LORAC DESIGN GROUP, LLC
Structural Engineers

Re: 4808 NE Jamestown Drive, Lee's Summit, Missouri – Structural Review
Lee's Summit, Permit # PRRES2021XXXX

This letter is to certify that I have personally inspected and verified through calculation the framing alteration noted in your review. We agree with those comments that unauthorized changes changed the load paths and created strength issues. Those have been addressed in the attachments

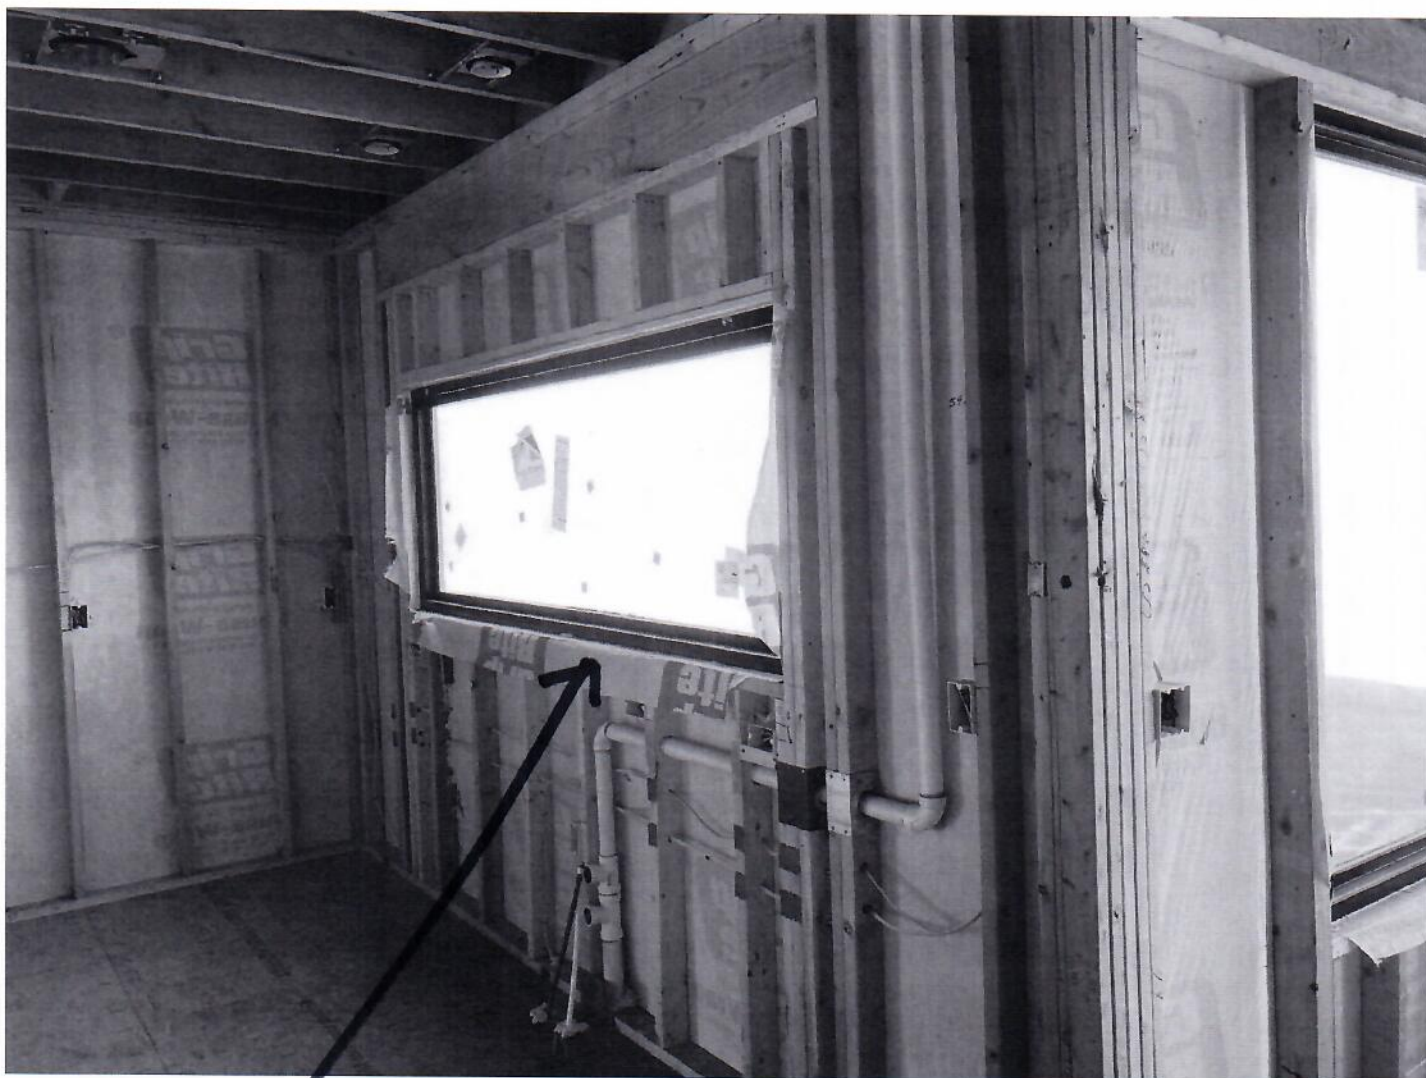
- Nail exterior siding per code
- Install trimmings and flashings per code
- Install all windows and doors
- Support front porch roof
- Garage PFH walls: nail straps, install 2"x2" washers

- Anchor garage sill plates per code
- Nail corner studs per code.
- How are the wall corners insulated?
- Complete gas piping to fireplace and retest. Fix leakage first. Pressure less than 10

- Support all hip rafters at ridge
- Fb all wall plates penetrations ; fb floor penetrations
- Protect refrigerator line
- Install hanger for triple joist connection above pantry

- Support (4)2x10 joist at I beam connection at rear dining/great room corner
- Have engineer address exterior wall bracing requirement at rear dining walls where windows and doors are changed from the approved plan

- Have engineer address address non-full-height 2x6 studs at rear great room walls
- Toe nail all joists to wall top plates
- Vent all bathroom fans

- Dryer duct exceeds max length allowed
- Pan off parallel electrical in return air space across from stair
